COUNCIL ASSESSMENT PANEL

for the meeting
Monday, 11 December 2023
at 5.30 pm
in the Colonel Light Room, Adelaide Town Hall

Agenda Item 3.1

Subject Site	111 Mills Terrace, North Adelaide
Development Number	22033267
Nature of Development	Demolish existing dwelling and construct two storey detached dwelling, boundary retaining walls and fences.
Representations	Listed to be Heard - Yes
Summary Recommendation	Planning Consent Refused
Status	Public

Figure 8.5.1 – Direct Overlooking as defined by the Planning and Design Code

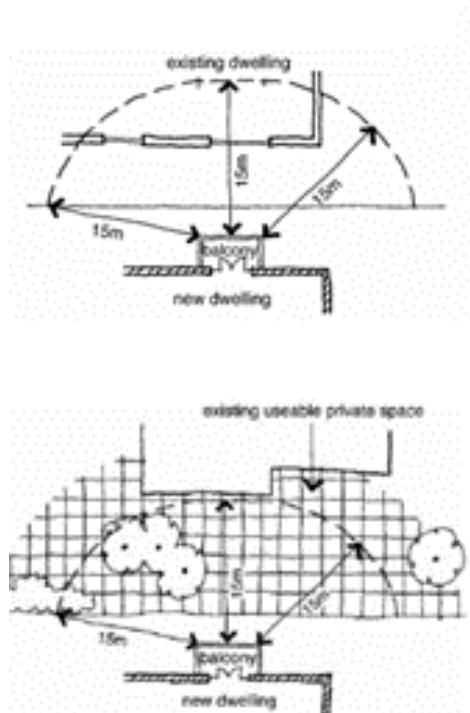
A balcony of 6.5 metres width and 1.35 metres depth is proposed to face the secondary side street above the garage with no screening proposed to the front of the balcony. Design In Urban Areas PO 10.2 prescribes development mitigate 'direct overlooking' from balconies to habitable rooms and private open space of adjoining residential uses in neighbourhood-type zones. Part 8 of the Planning and Design Code defines 'direct overlooking' as demonstrated in Figure 8.5.1.

Figure 8.5.2 – Diagram indicating 15 metre radius from front of balcony

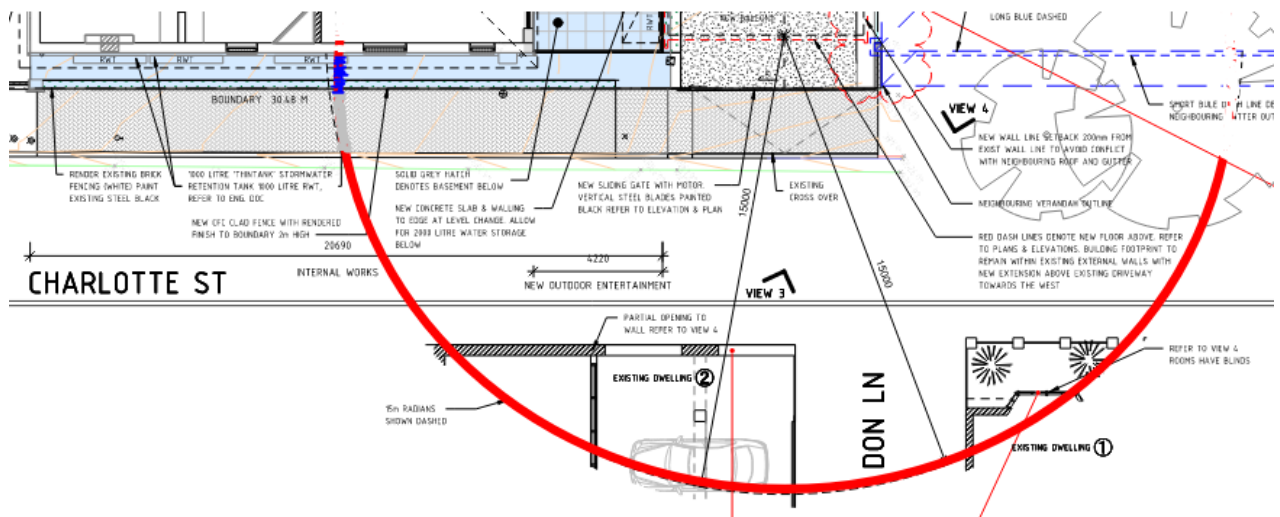
The site plan indicates a portion of the front yard of the adjacent dwelling to the west at 11 Charlotte Street, as well as a portion of the rear of the adjacent dwelling at 227 Gilles Street, will be within 15 metres of the proposed balcony as shown in Figure 8.5.2.

With regard to 227 Gilles Street, the area of the site within view appears to be for the purposes of vehicle parking, and contains a small domestic shed, indicating this area is not used for recreational purposes but instead as a service yard. In relation to 11 Charlotte Street, it is understood the front room on the lower level is a living room, while the front room on the upper level is a bedroom. The proposal therefore does not appear to mitigate 'direct overlooking' from the balcony into the habitable rooms of 11 Charlotte Street.
